PUBLIC INTEREST REVIEW FOR GROUND WATER APPLICATIONS

SUBJECT: Application G- 17401 Supersedes review of August 5, 2010
Date of Review(s)

A. GENERAL INFORMATION: Applicant's Name: Joe and Joyce McKay County: Malheur

Application G-17401, Joe and Joyce McKay

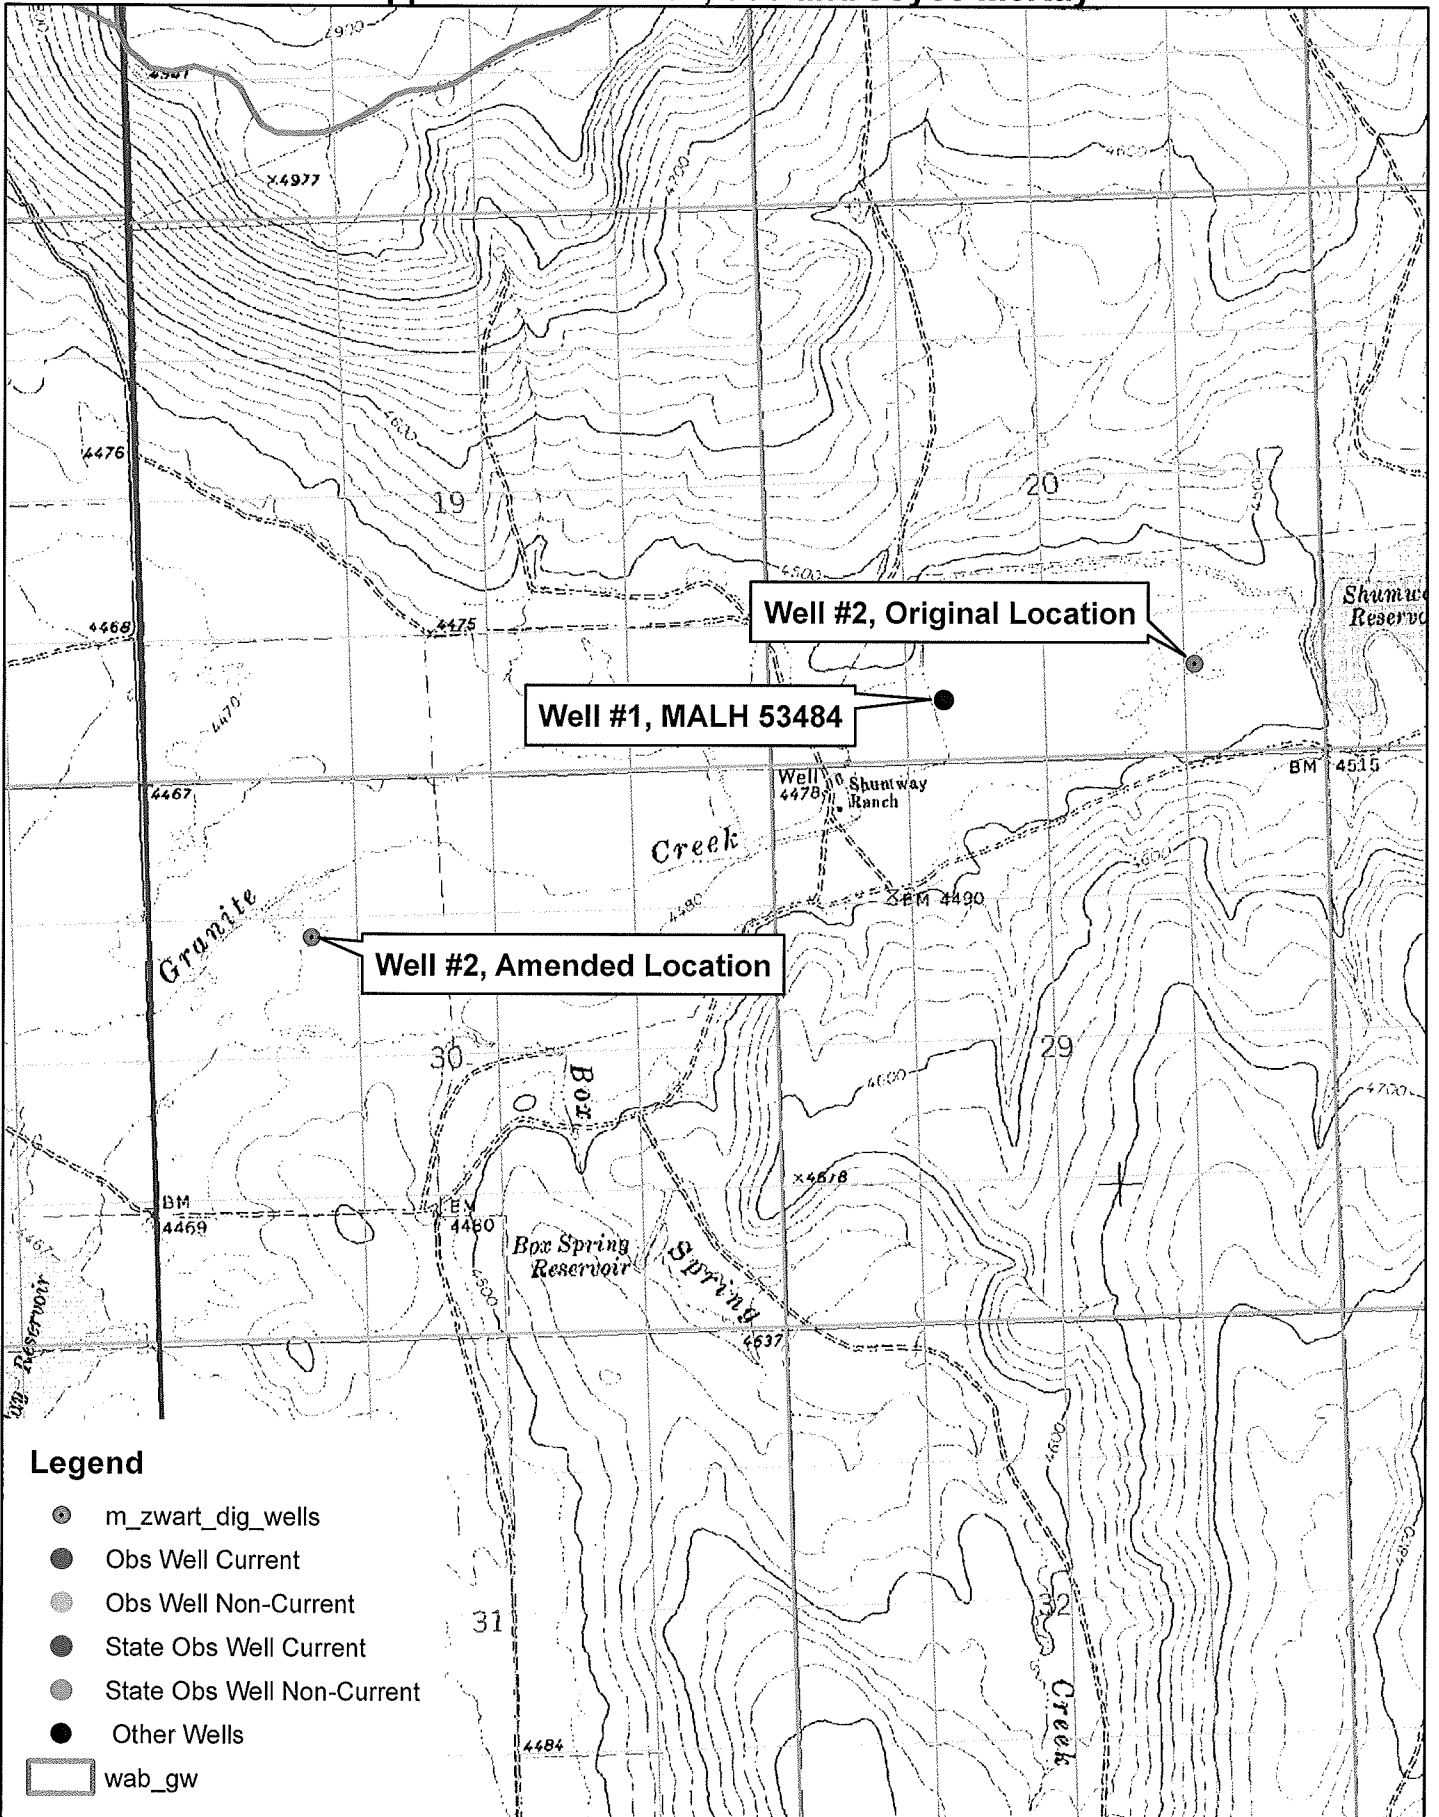
A4. **Comments: Wells likely developing Shumuray (sic) Ranch Basalt of Kittleman, et al, 1967. The applicant called on 08/31/2012 with a GPS location for a revised proposed location for well #2.**

Basis for aquifer hydraulic connection evaluation: Both local wells have water levels well below the nearby reach of the creek. Proposed well #2 may have a considerably deeper water level than is estimated here, based on the reported water level in MALH 52092 located nearby. It does not appear that groundwater is providing baseflow to local creeks.
